Technical Note 170232-TN-05

Project:	Residential Development, Scholarstown Road, Dublin 16	Prepared by:	Brendan Keogh
Title:	Response to ABP Opinion, Item 1, SDCC Water Services & Irish Water	Date:	26/09/2019
Client:	Ardstone	Job No:	170232

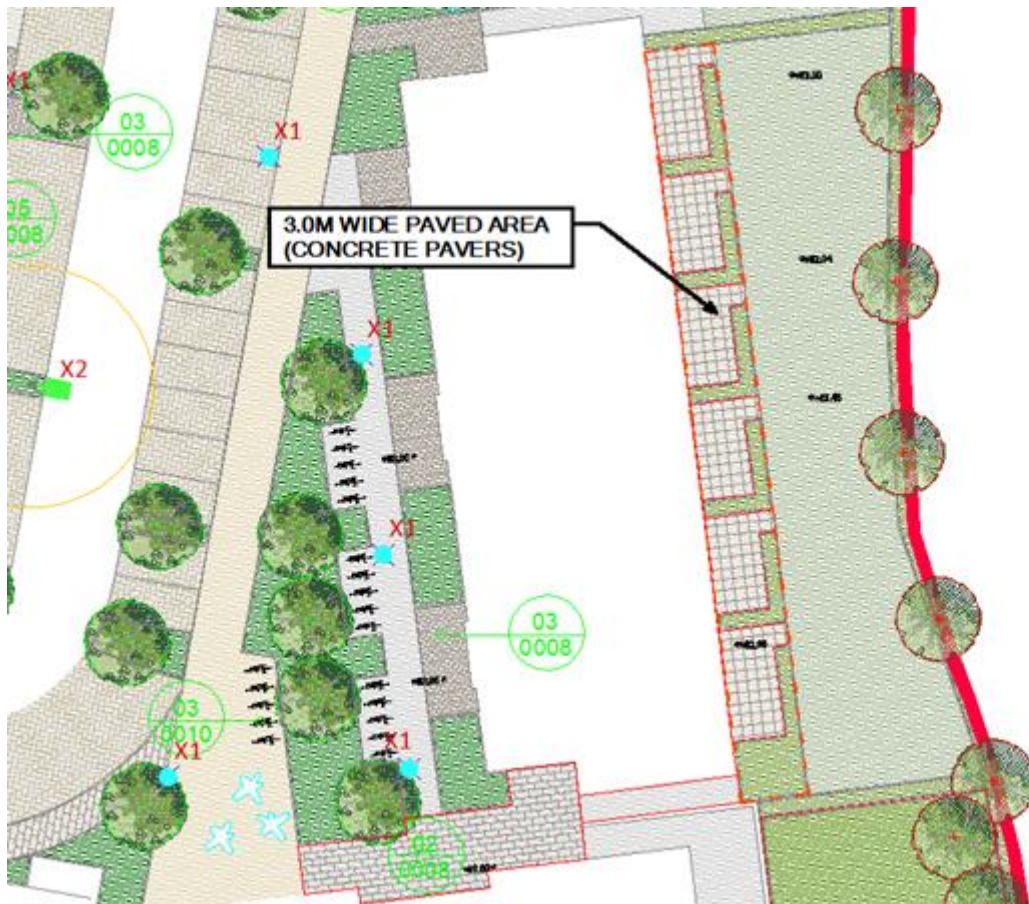
Just following up on discussions earlier today regarding the wayleave at Ardstone's lands in Scholarstown.

For reference I've also attached the proposed wayleave plan as tabled at yesterday's meeting.

At the rear of each duplex unit it's proposed to have a 3.0m wide patio area comprising of concrete pavers (see snip below).

1. No permanent structures with foundations may be constructed on the wayleave.
2. The wayleave must be registered in favour of South Dublin County Council with the Property Registration Authority.

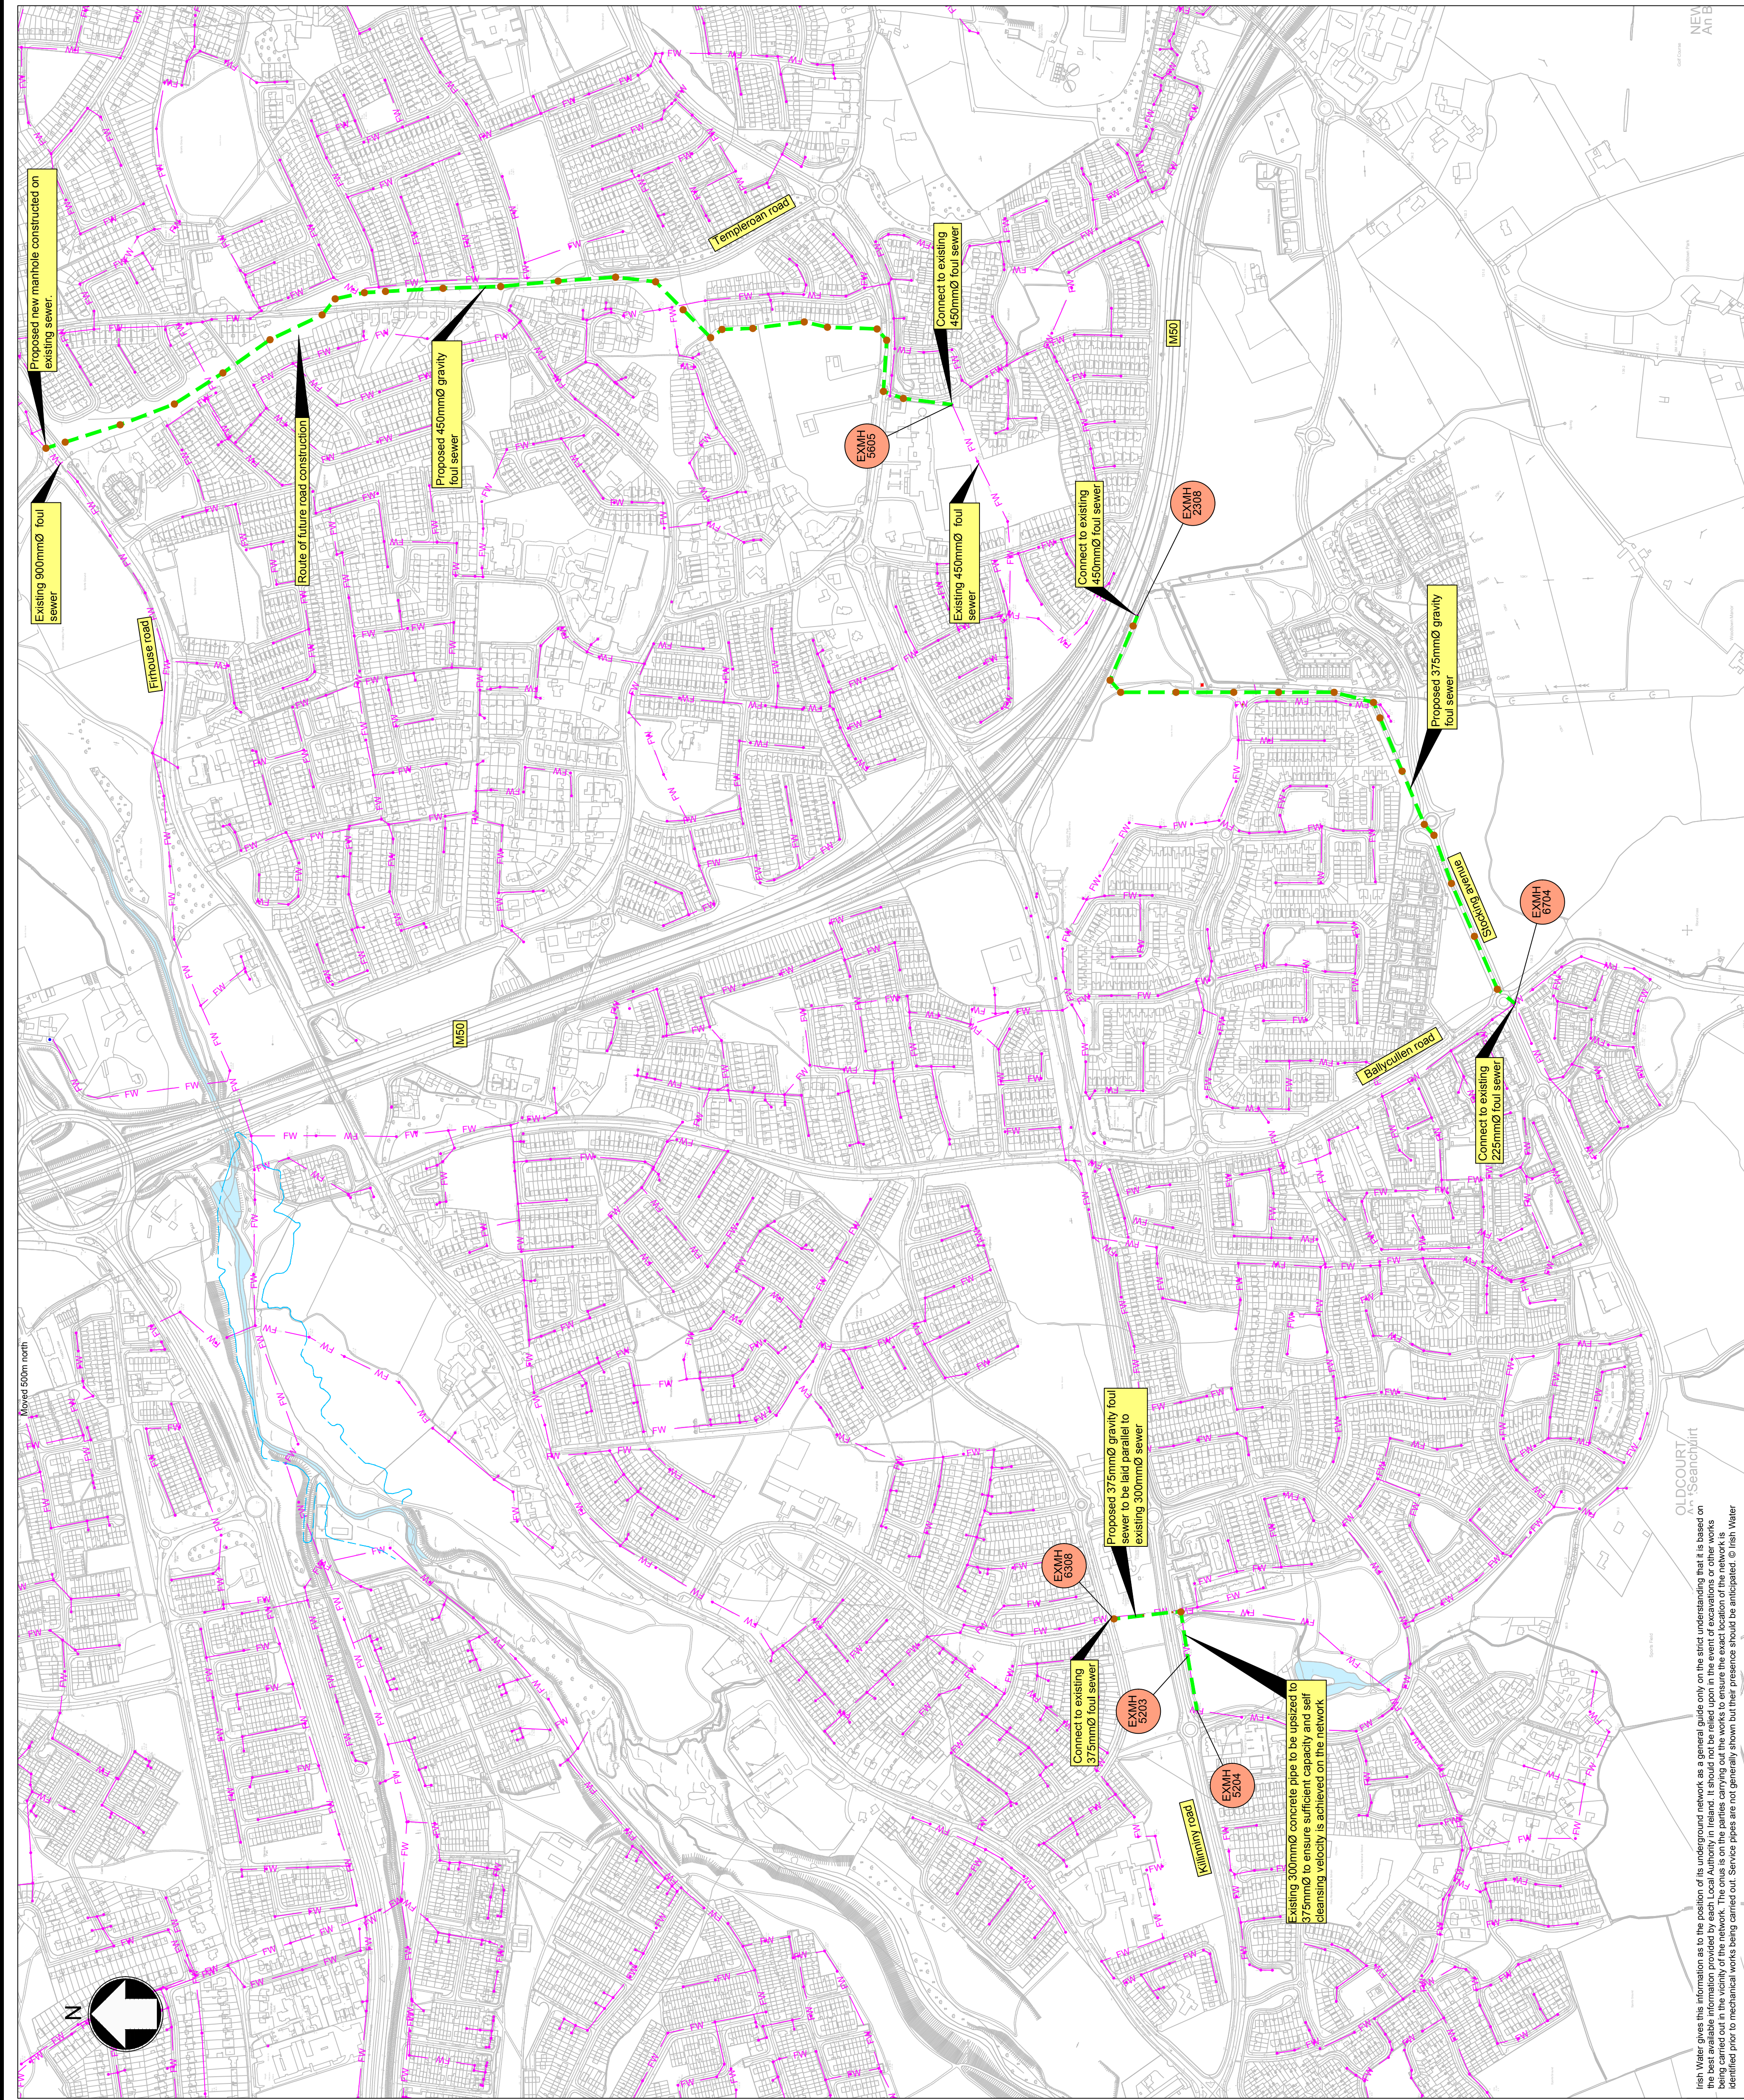
New connection to the existing network is feasible subject to network upgrade. Upsizing of existing 150mm ID main in Scholarstown and Oriagh Grove Road to 200mm ID for approximately 395m will be required. Irish Water currently does not have any plans to commence upgrade works to its network in this area.

This Confirmation of Feasibility to connect to the Irish Water infrastructure also does not extend to your fire flow requirements. Please note that Irish Water can not guarantee a flow rate to meet fire flow requirements and in order to guarantee a flow to meet the Fire Authority requirements, you should provide adequate fire storage capacity within your development.

There are significant wastewater network constraints in the area and downstream of the site. New connection to the existing network is feasible subject to network upgrade. Irish Water currently has a project on current investment plan which will provide the necessary upgrade and capacity. This upgrade project is scheduled to be completed in 2021. There is a section of proposed 450mm ND sewer as a part of the Project running through the site parallel to the East boundary. A wayleave in favour of Irish Water will be required for the infrastructure.
